July 19, 2016

Re: Arborist Review Tree Permit #2016-ARP-0012, Review and Recommendations
Site: Home Heroes 7, LLC property, 195XX 53rd Ave NE, Lake Forest Park, WA 98155.

Figure 1: Tree Protection Fence.

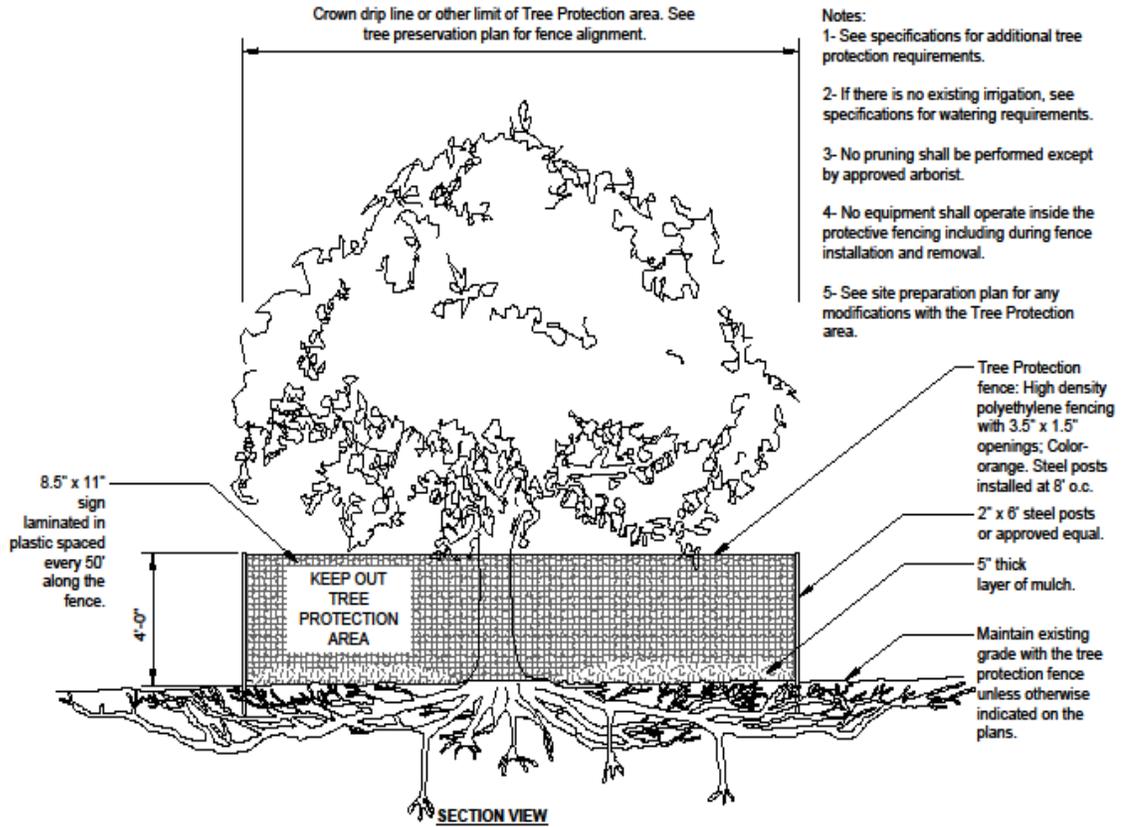
1. Install continuous semi-circular TPF, of polyethylene laminar safety fencing material, a minimum of 4 feet high and supported by metal fence posts, spaced approximately 4 feet apart, in a radial arc 15 feet from the trunk of the tree. Installation of the TPF facing the construction zone shall be as close to the edge of work as feasible, if less than the recommended 15 feet. Installation of the TPF facing the construction zone shall be as close to the edge of work as feasible, if less than the recommended 15 feet.
2. Place a layer of mulch, woodchips are recommended, at least 4" in depth covering the area within the TPF.
3. The area within the tree protection fencing is the Tree Protection Zone (TPZ) and nothing must be parked or stored within the TPZ; no equipment, vehicles, soil, debris, or construction supplies of any sorts.

The Tree Protection Fences need to be clearly marked with the following or similar text in four inch or larger letters:

Refer to Figure 1: Tree Protection Fence diagram.
